SUBDIVISION REVIEW SHEET**CASE NO.:** C8-2020-0112.1A**COMMISSION DATE:** July 5, 2022**SUBDIVISION NAME:** Braker Valley Subdivision (a small lot subdivision)**ADDRESS:** 4806 Blue Goose Rd**APPLICANT:** RR Braker Valley, LP (Jeremy Smitheal)**AGENT:** BGE, Inc. (Chris Rawls)**ZONING:** I-SF-4A (single family residence, small lot subdivision)**NEIGHBORHOOD PLAN:** N/A**AREA:** 68.615 acres**LOTS:** 211**COUNTY:** Travis**DISTRICT:** 1**WATERSHED:** Walnut Creek**JURISDICTION:** Full Purpose

**CITY OF AUSTIN –DEVELOPMENT SERVICES DEPARTMENT
SUBDIVISION APPLICATION – MASTER COMMENT REPORT**

CASE NUMBER: C8-2020-0112.1A
 UPDATE: U0
 CASE MANAGER: Joey de la Garza PHONE #: 512-974-2664

PROJECT NAME: Braker Valley Subdivision Final Plat
 LOCATION: 4806 BLUE GOOSE RD

SHEET 3 OF 7

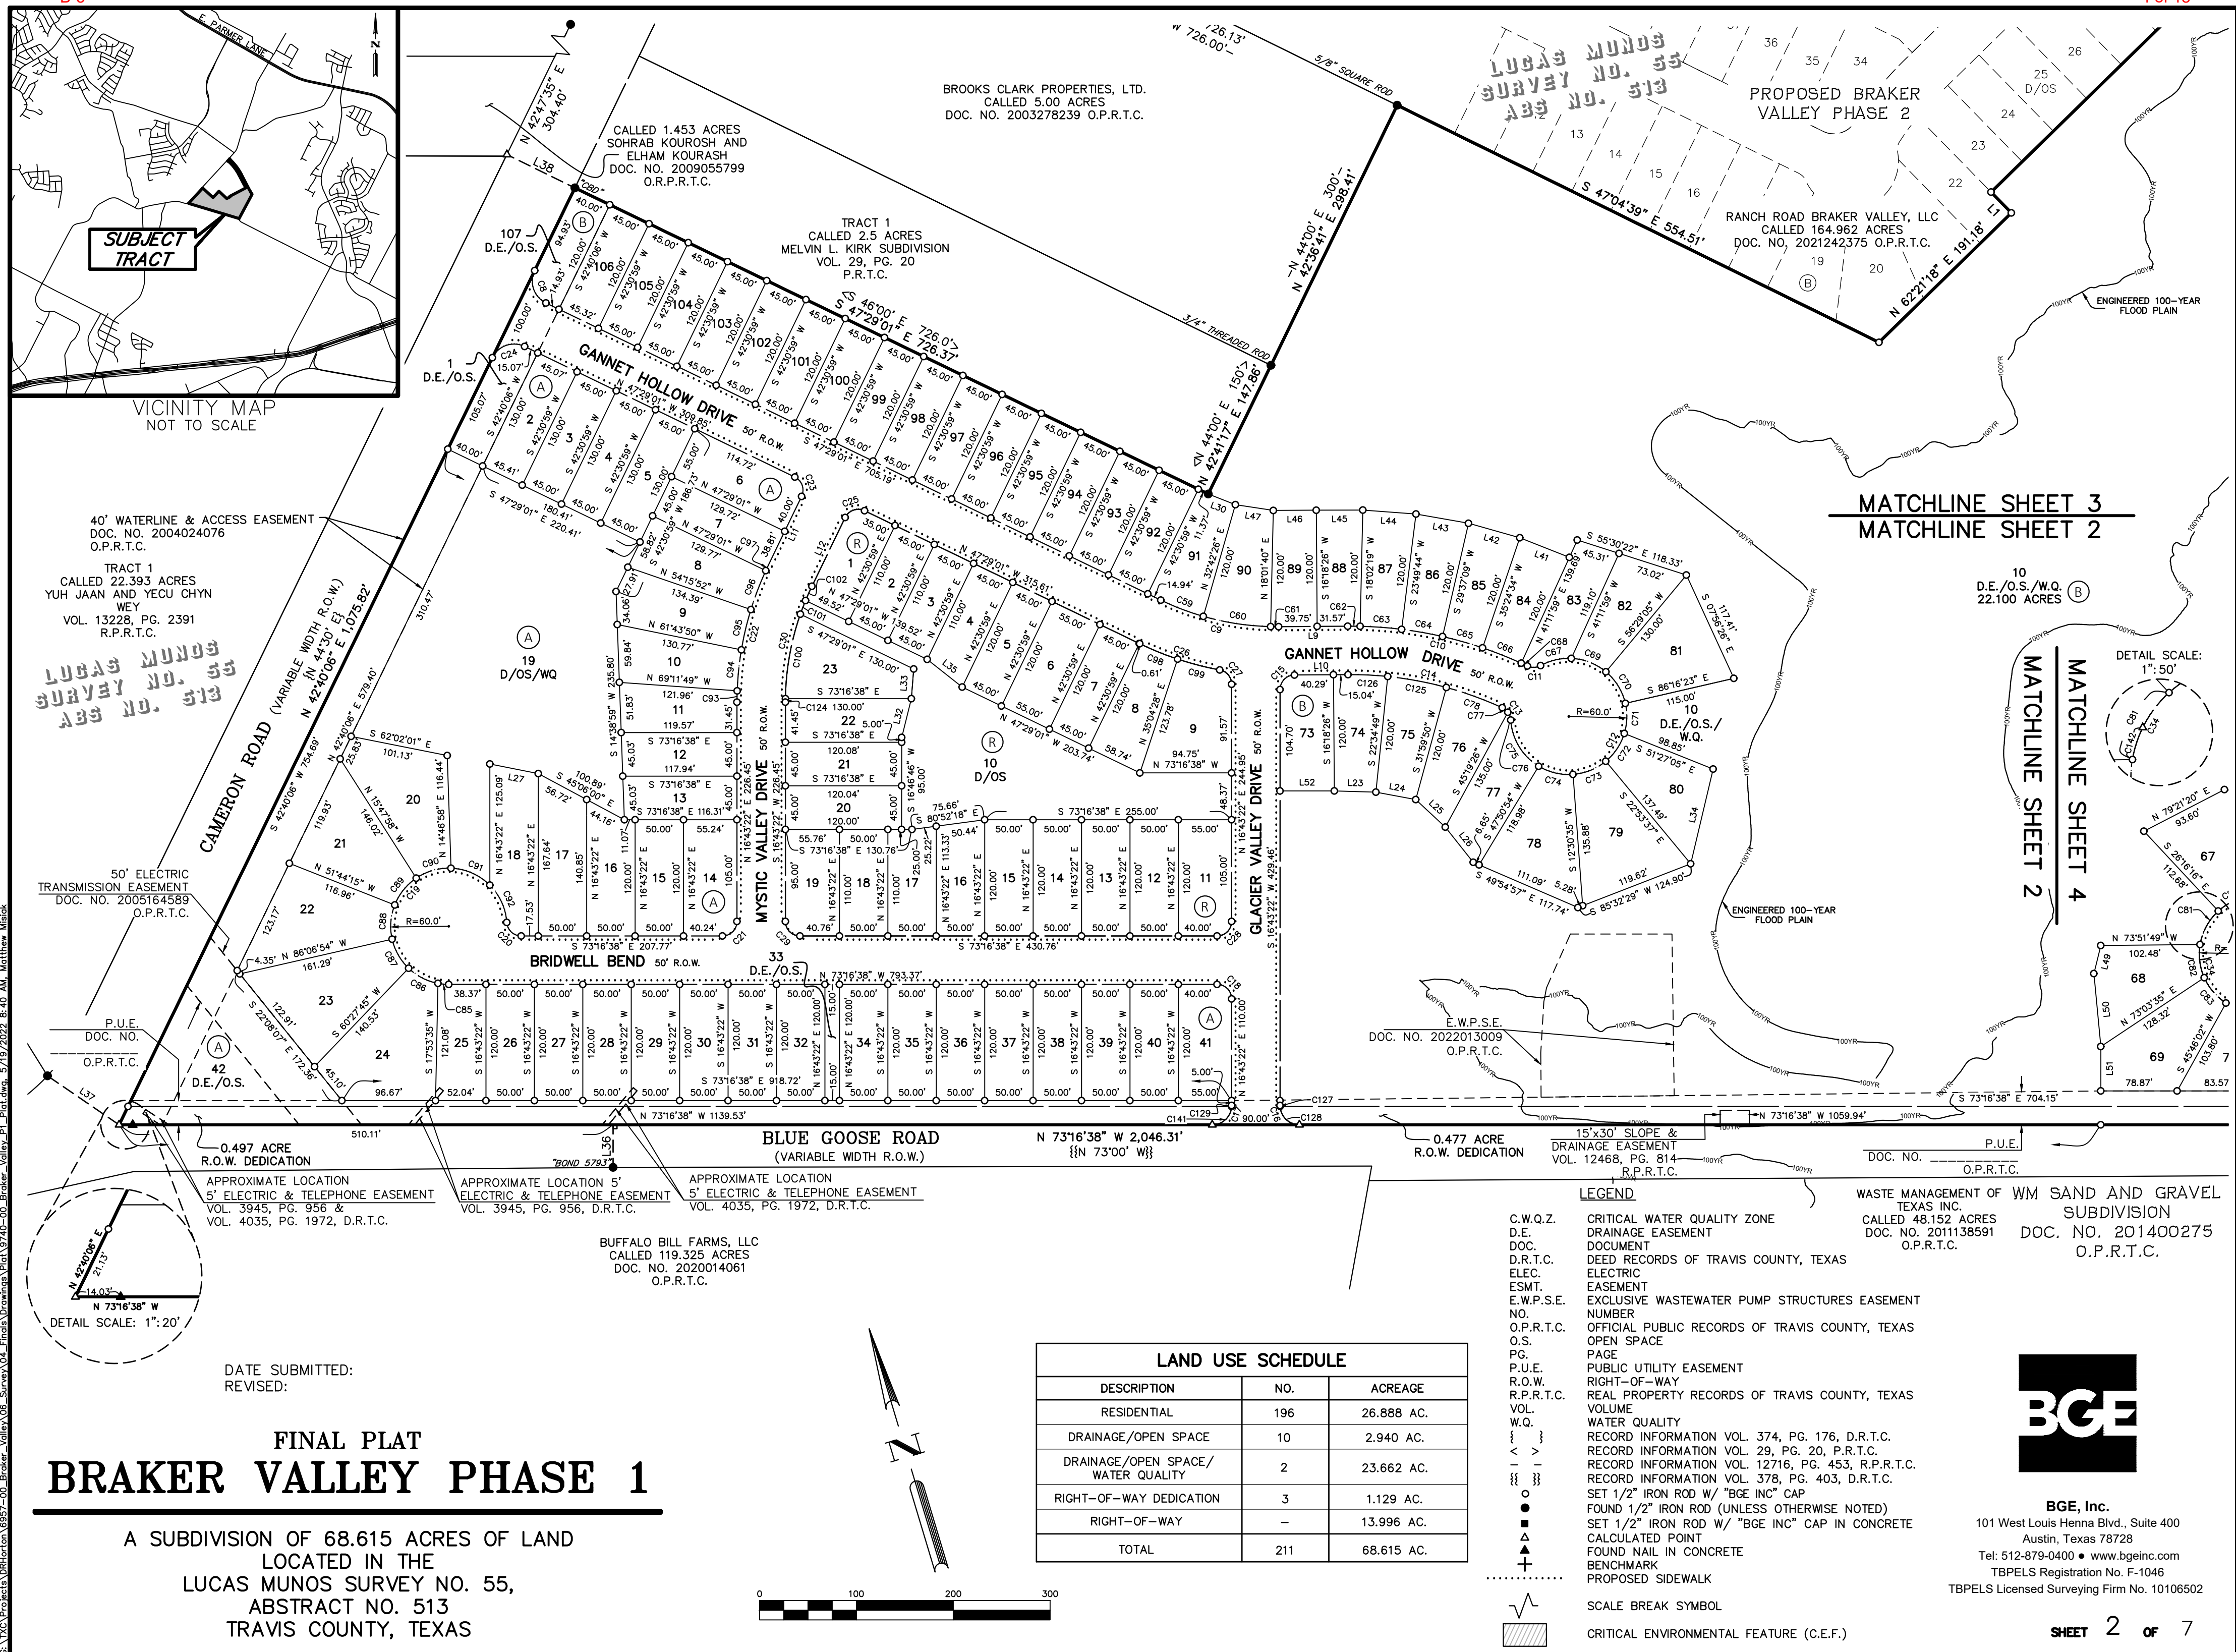
- AD7: On sheets 3, 4, 5 and 6, on all places where E BRAKER LN is labeled, the labels should be as follows: **E BRAKER LN (Proposed)**. Optionally, the word PROPOSED enclosed within parenthesis, may be placed below the street name label. No punctuation should appear in the street name label
 Example:
E BRAKER LN
(Proposed)

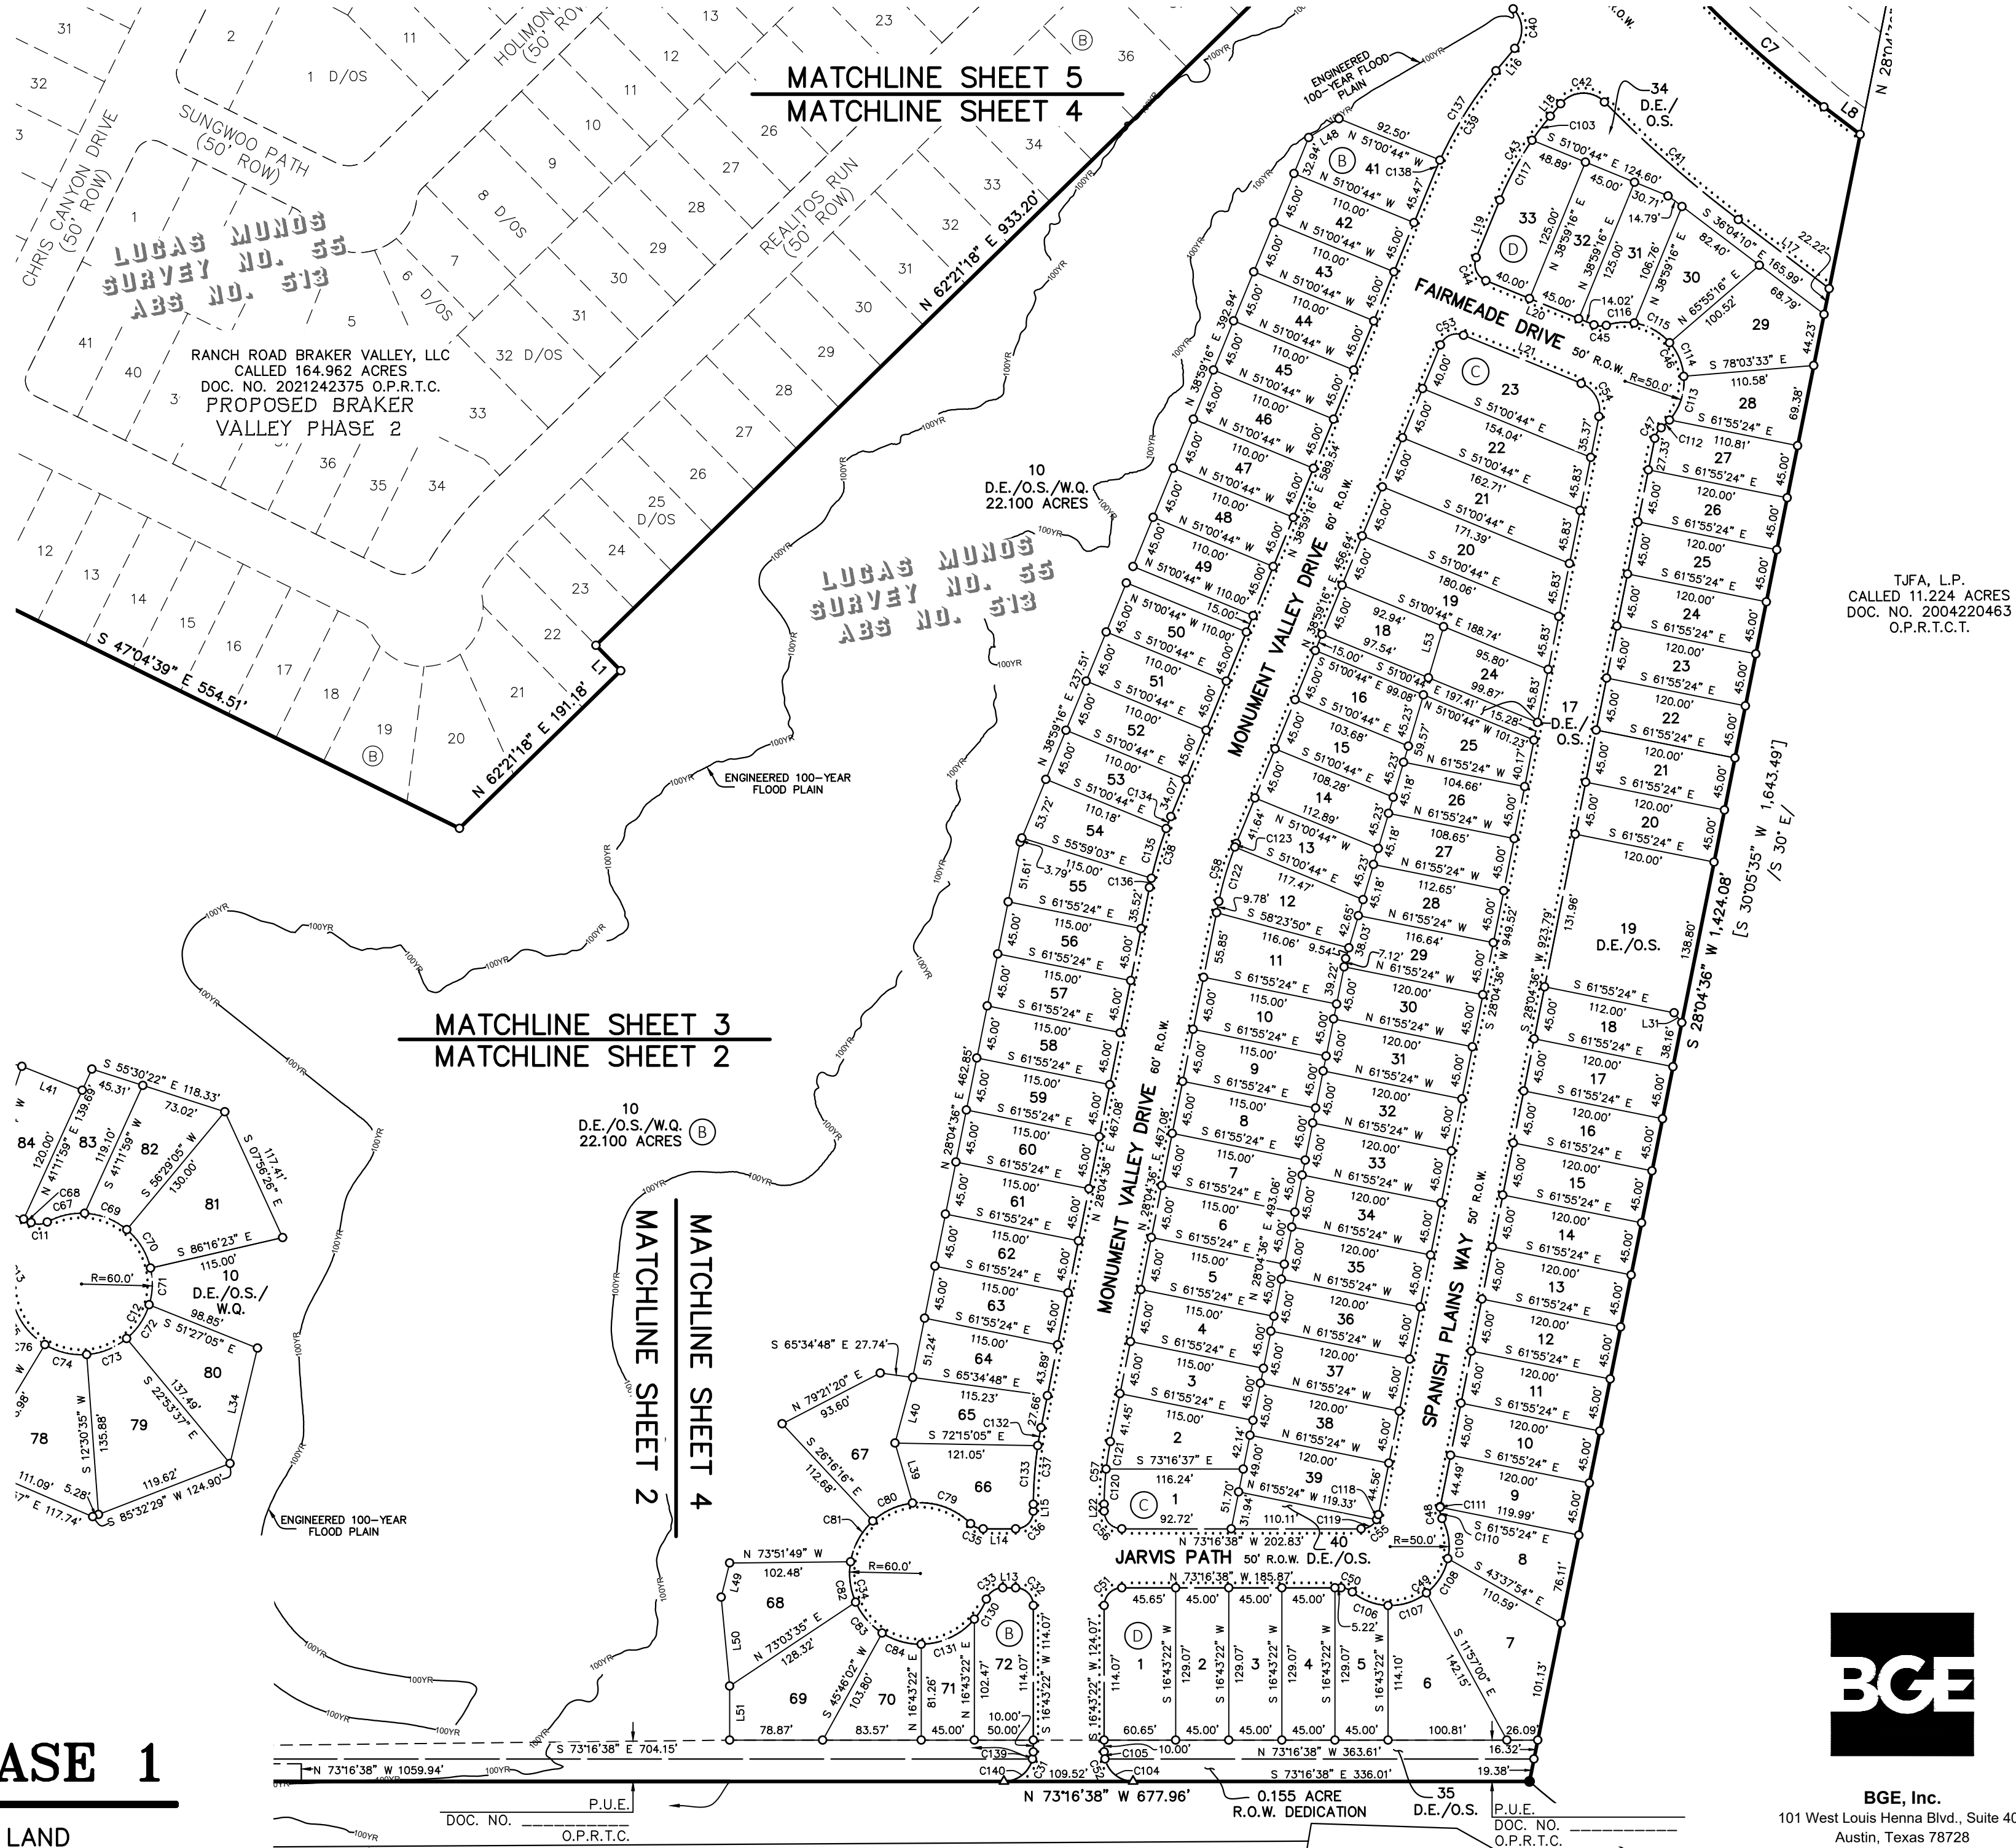
- AD3: Although GANNET HOLLOW DR was approved, in our current standards both HOLLOW and DRIVE are street types. A street name can only have one street type. The street name GANNET is already in use elsewhere, so please **select a new modifier word** for GANNET and use only one street type word. Reference Appendices C and D of the Street Name Standards. Add a **flyout label** for this street on sheet 4

- AD5: Add the label of **MOUNTAIN VALLEY DR** to sheet 5, a flyout label is acceptable
- AD6: JARVIS PATH is the name of the entire street, on both sides of Monument Valley Drive. It would be appropriate to add a label for the portion of this street surrounded by lot block B and lots 68-72

- AD8: Update the street name table label entry for EAST BRAKER LN to **E BRAKER LN**
- AD9: A portion of the label for **FAIRMEADE DR** is missing on sheets 3 and 5, a flyout label is acceptable
- AD10: It would helpful if a label were added to sheet 4. Please add a **BLUE GOOSE RD** label
- AD11: In the vicinity map, add labels for **BLUE GOOSE RD** and **CAMERON RD**
- AD12: In the vicinity map and sheet 5, remove the punctuation from the label for **E PARMER LN**
- AD13: Please **update the Street Names table** on sheet 6 with the revised names as they are reserved and approved. Only approved street names may be used on the final plat
